**PENDRAGON
THEATRE -
RENOVATION
& ADDITION**

**DD PROGRESS
DRAWINGS -
NOT FOR
CONSTRUCTION**

**RE: Pendragon Theater Site Plan Application
Proposed Rebuild/Redevelopment
56 Woodruff Street
Village of Saranac Lake, NY 12983
LaBella Project 2222500.01**

Drawing Title: **LANDSCAPE PLAN**

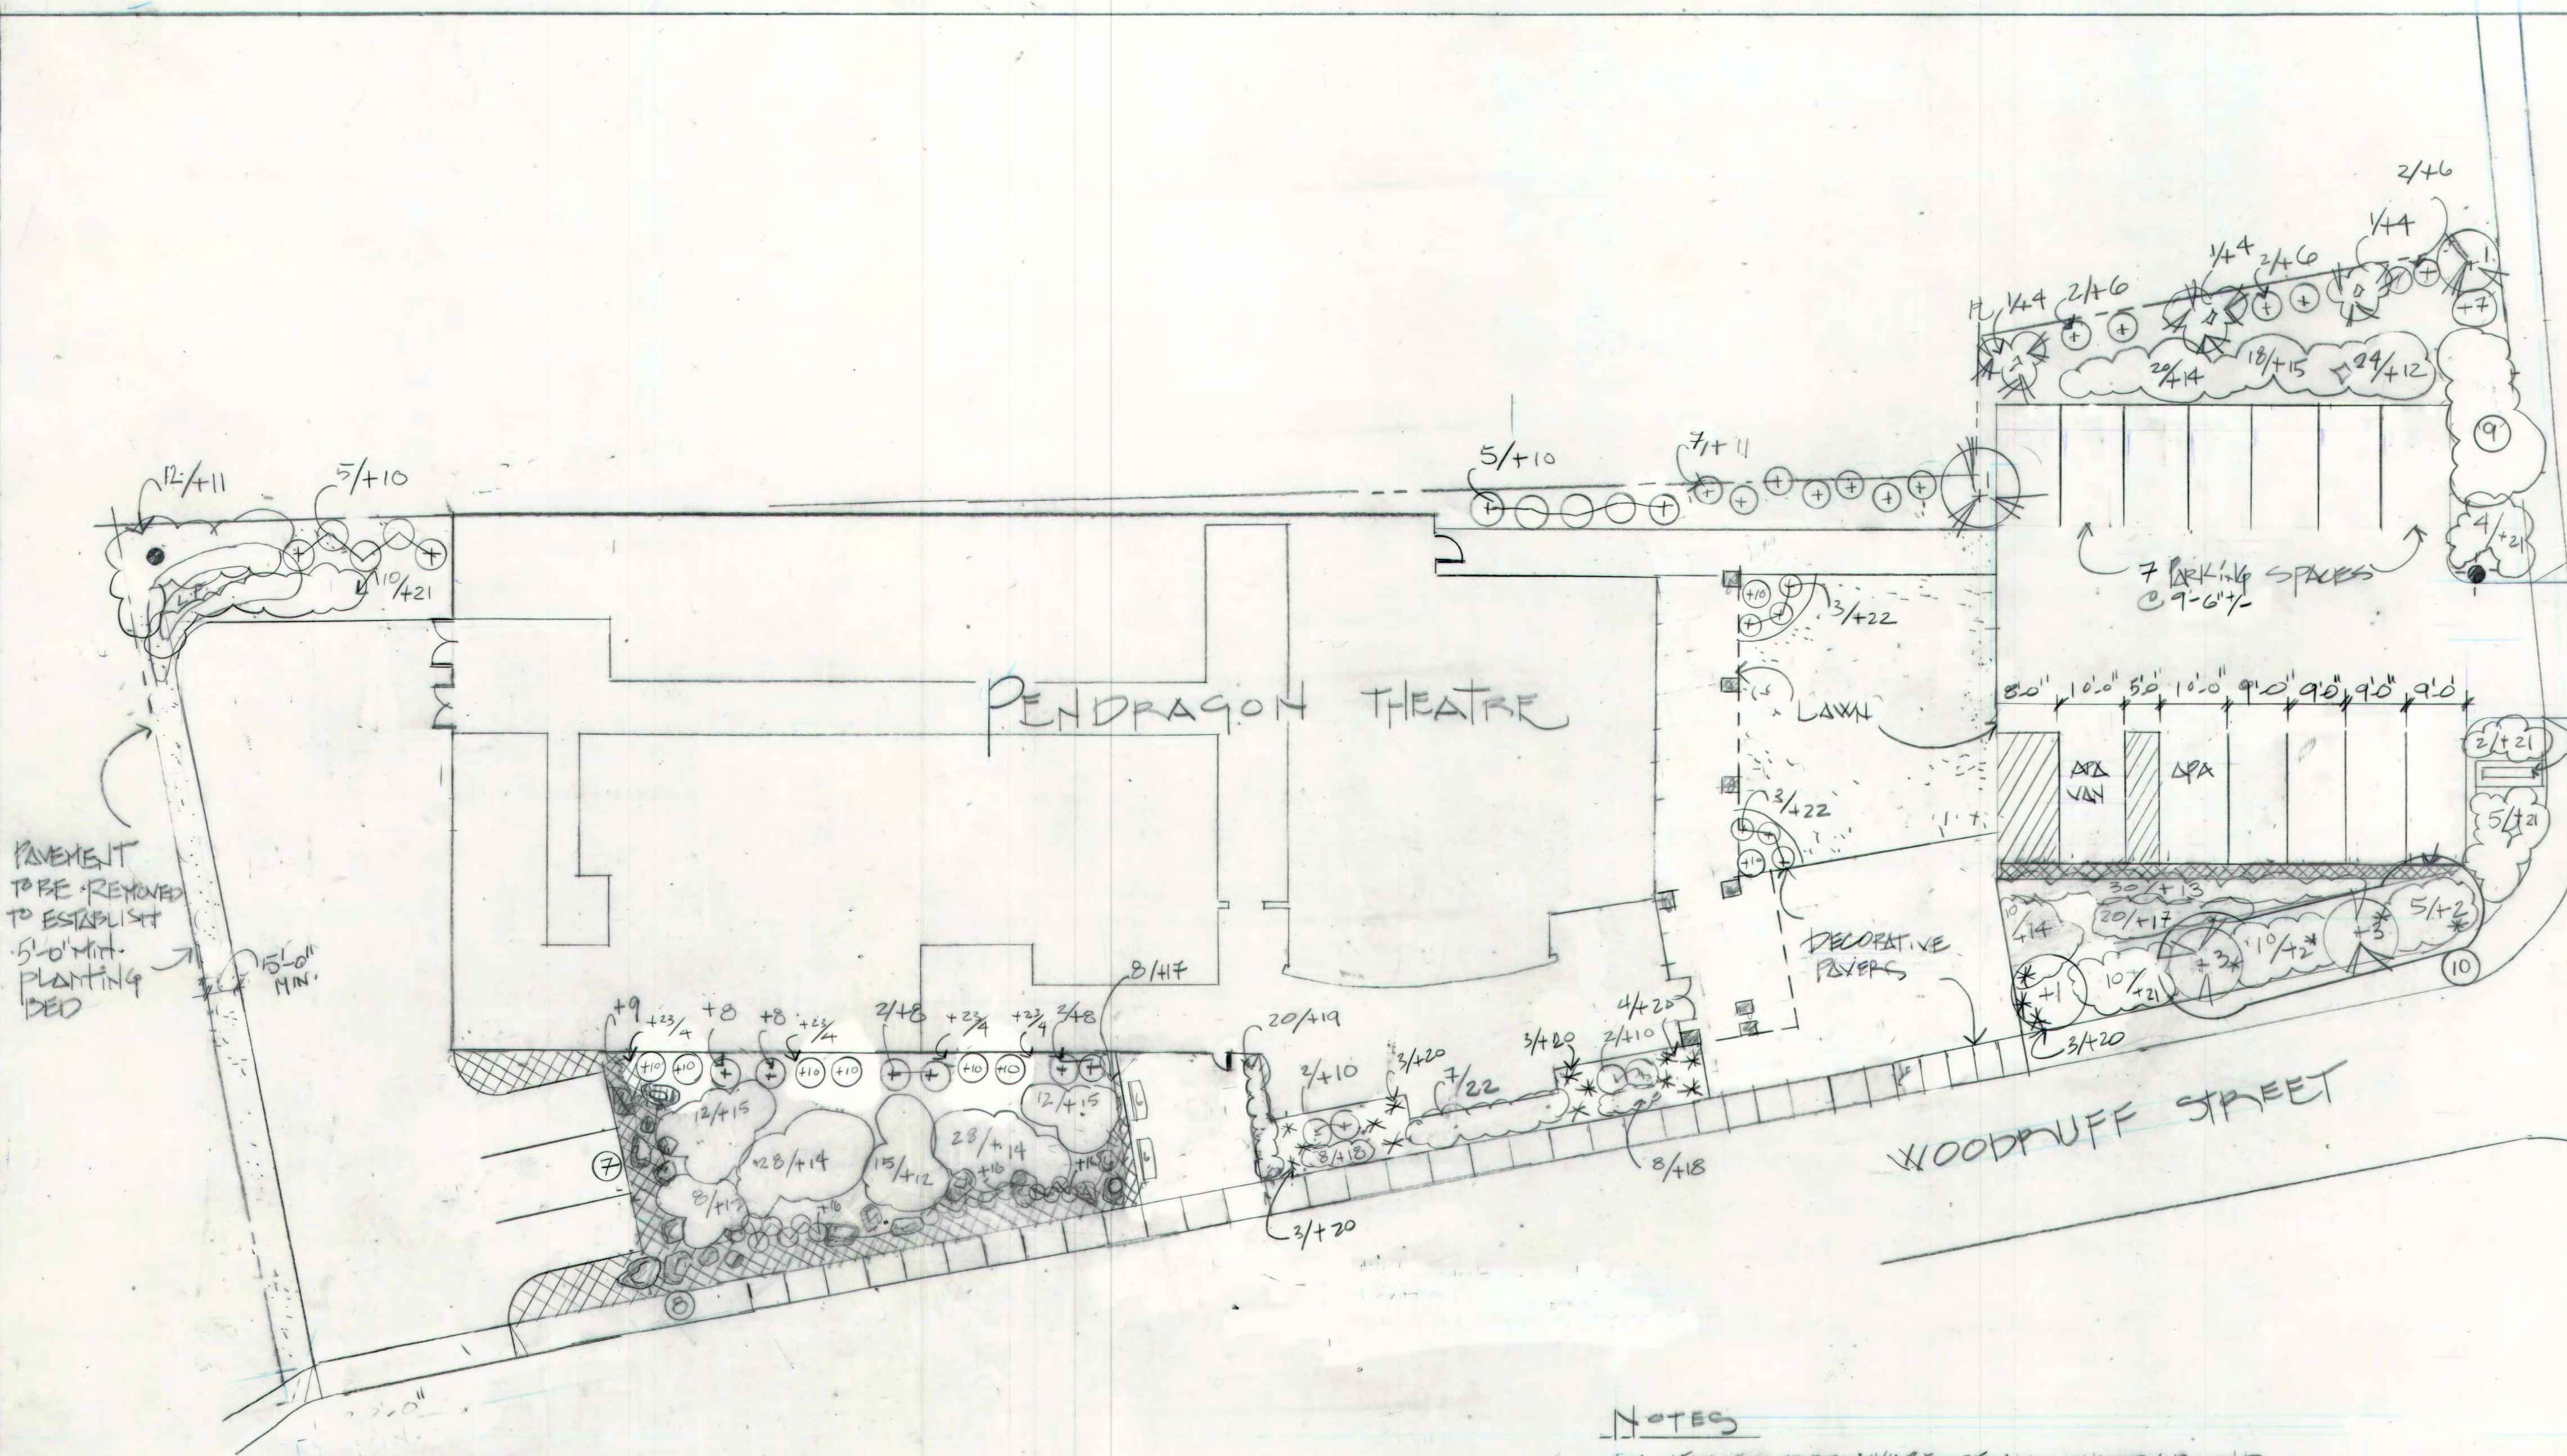
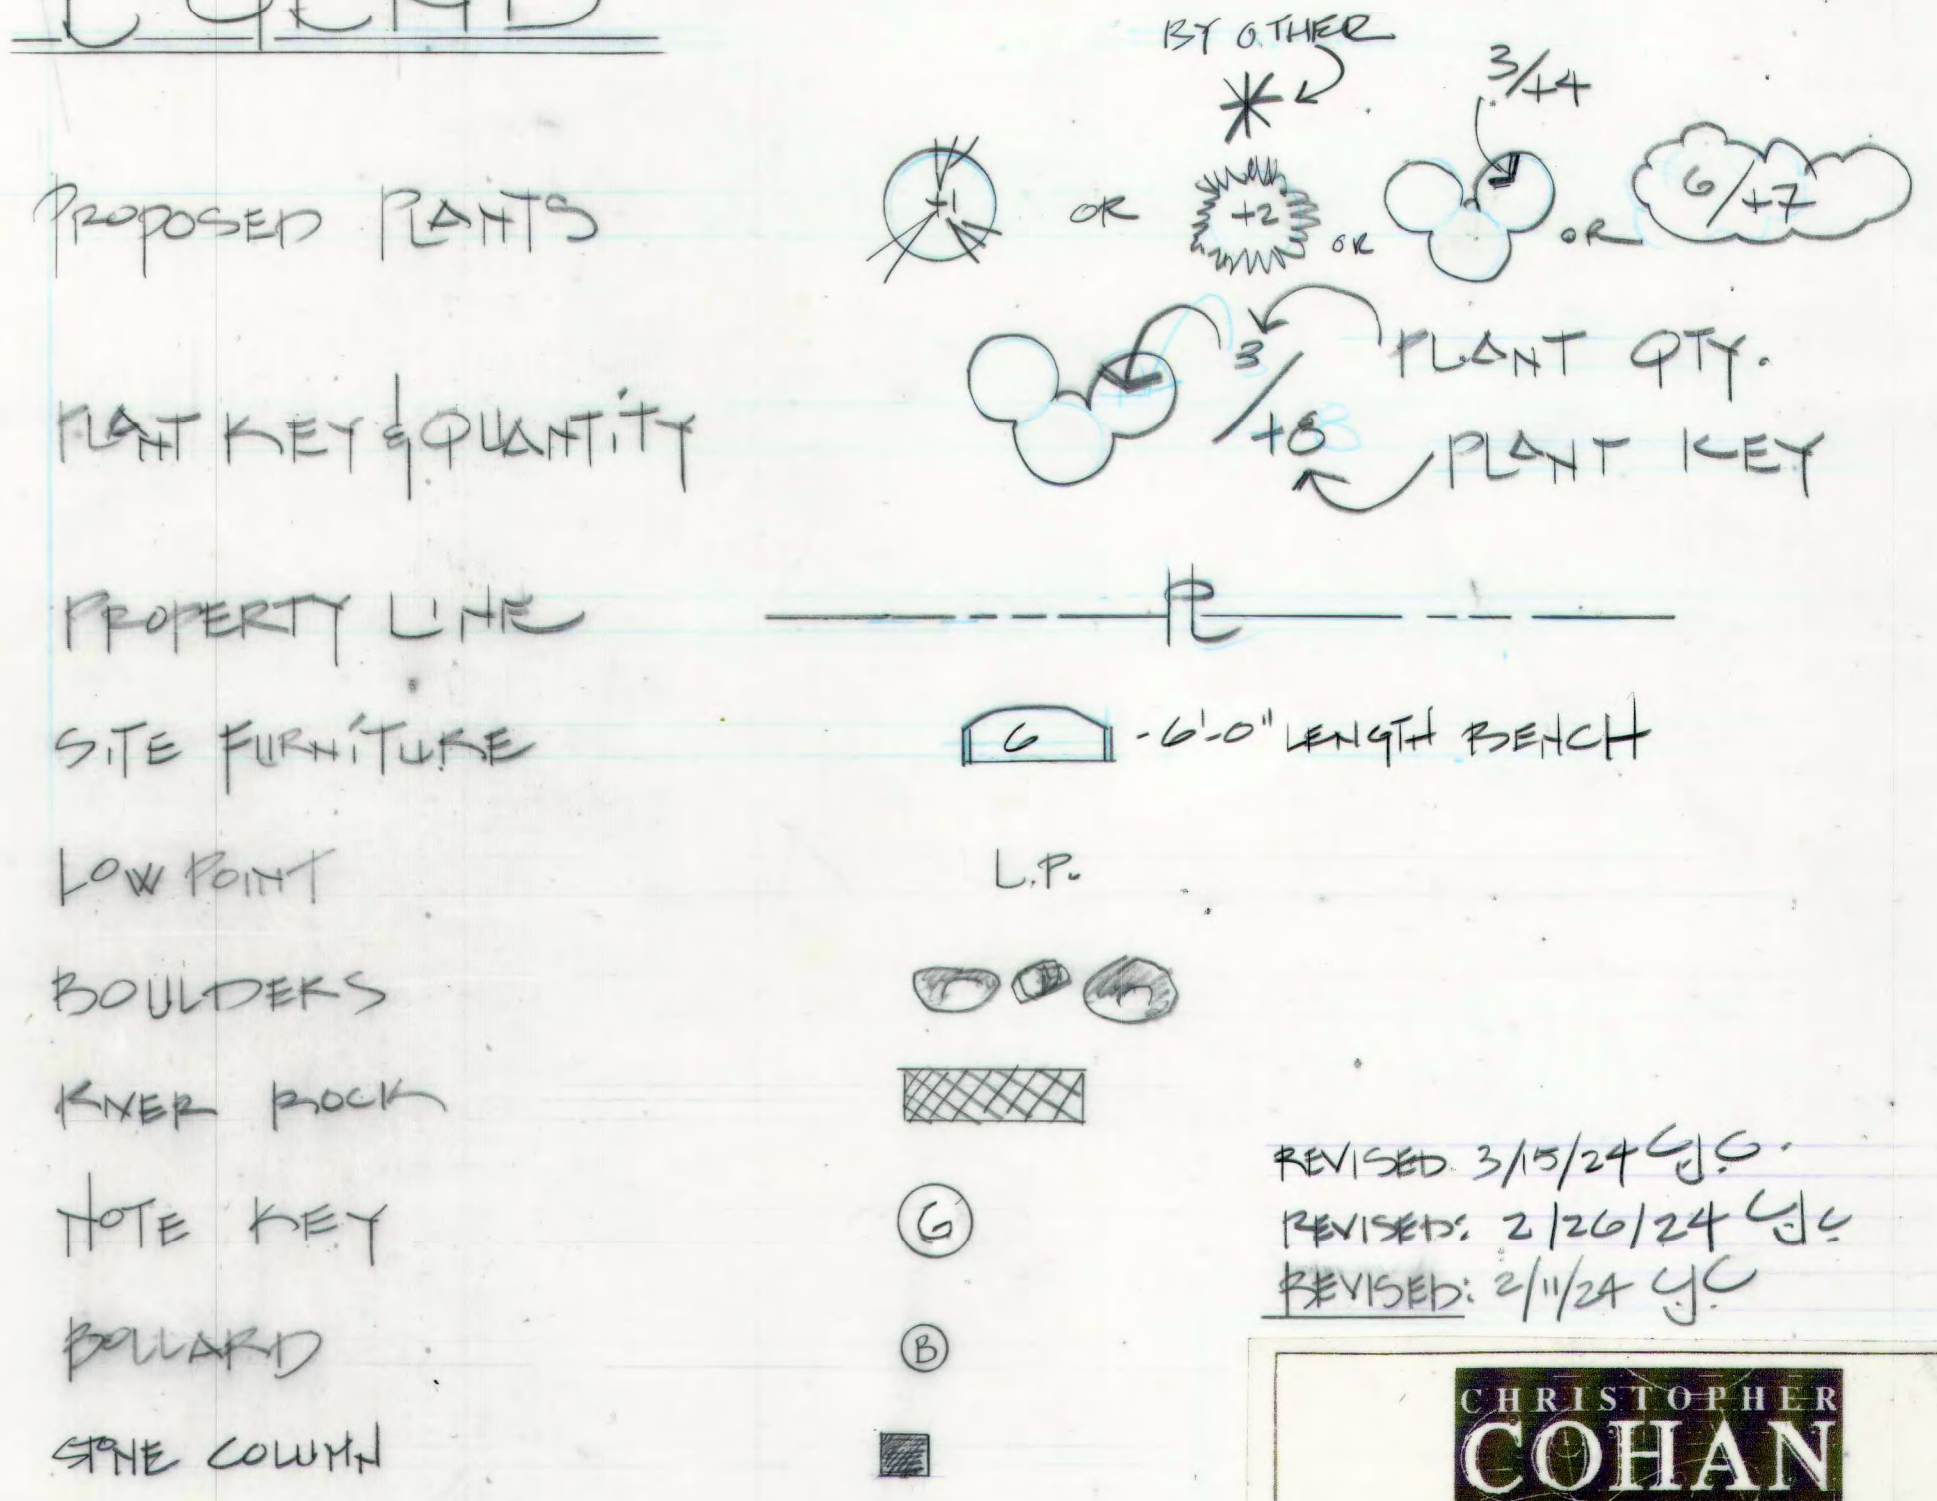
13. Per the requirements within the Village Code section 106-82 E.11. "Transformers, Dumpsters, and other utilities should incorporate landscape elements to screen them from view." The Development Board should review the proposed landscaping plan and make a determination of whether it is sufficient for the project site. Documentation of their opinion should be provided.
14. It appears that the proposed landscaping plan does not incorporate the concrete pad for HVAC. Please advise.
15. Cut Sheets for the proposed area lighting have been provided. Applicant should provide a lighting plan to indicate there is no offsite light spillage.
16. Landscape symbols on the proposed Site Plan do not match the Landscaping Plan. Plans need to be reconciled and plantings need to be coordinated with existing and proposed utilities.
